Supersedes:
N3382A-01A

N3382A PNA Series RF Network Analyzers

July 26, 2007

Figure 1

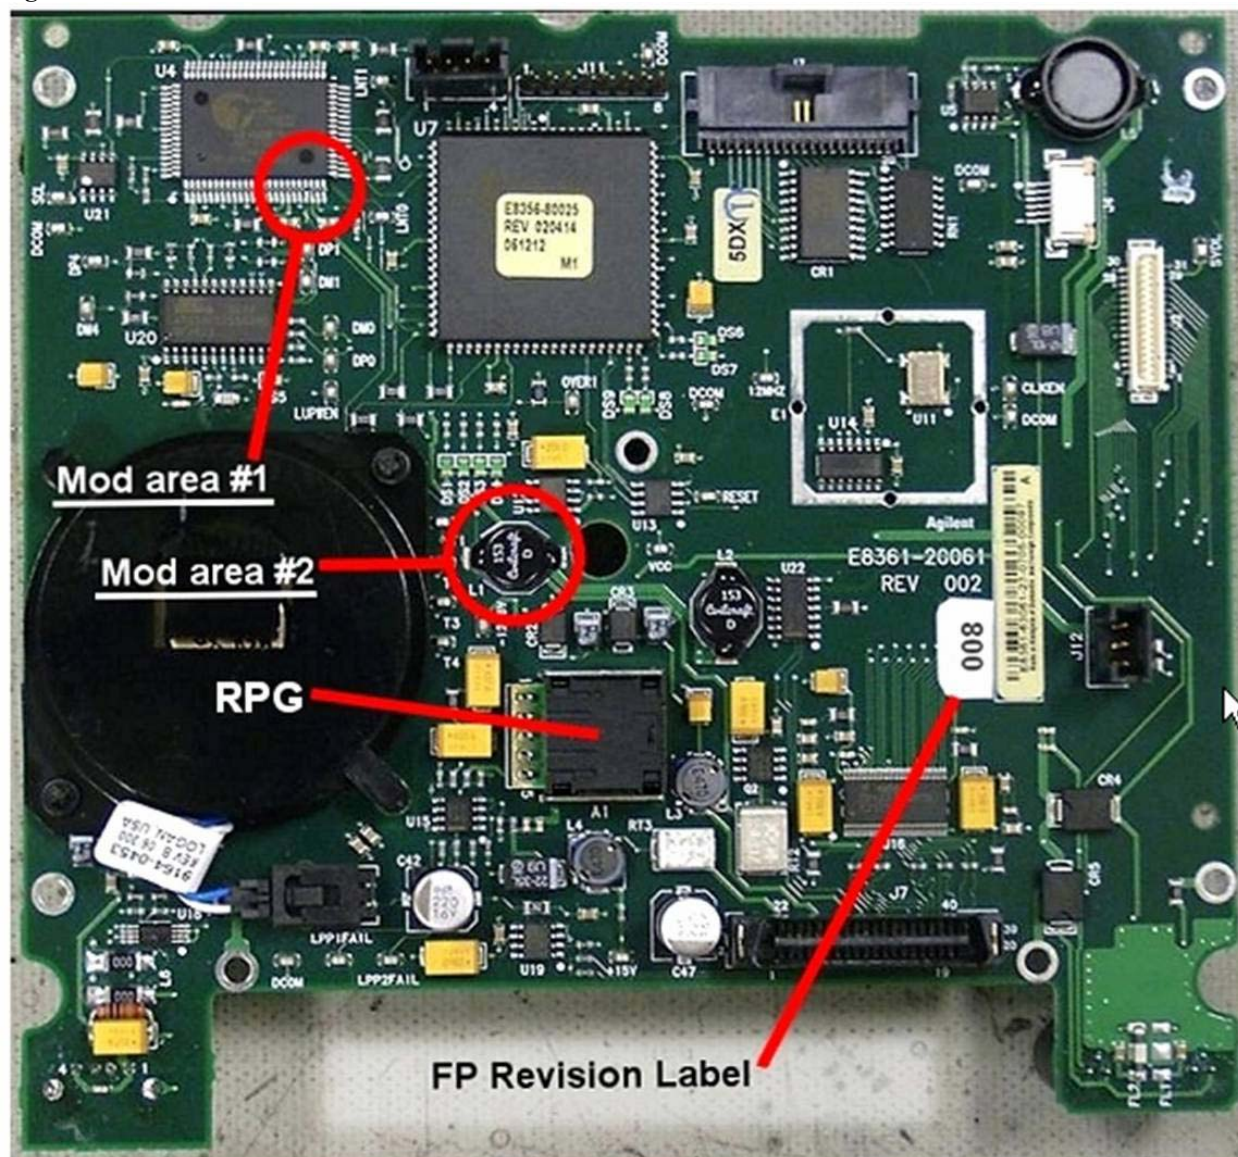
Refer to Figure 1 for the two modification areas to be addressed. Note that while this picture happens to show the FPI board completely removed from the front frame assembly, this is not necessary to perform the required modifications.

- Modification #1 consists of shorting two pins of U4 together with a small amount of solder.
- Modification #2 consist of removing L1.

Figure 2

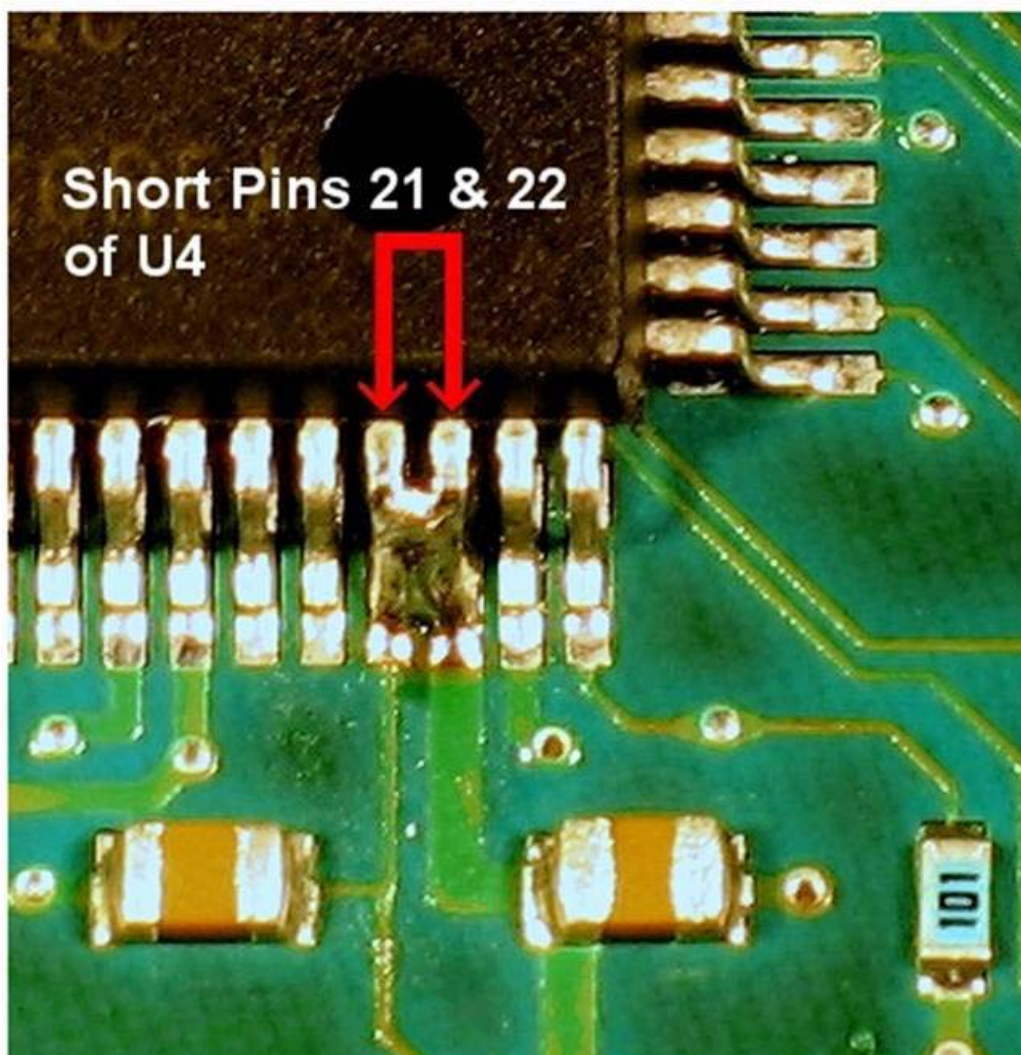
Carefully solder pins 21 and 22 together on U4. Refer to Figure 2 for the exact location. Use care so that no other pins are shorted. Use of a very fine tip soldering iron is recommended and a large work-task magnifying glass is very helpful.
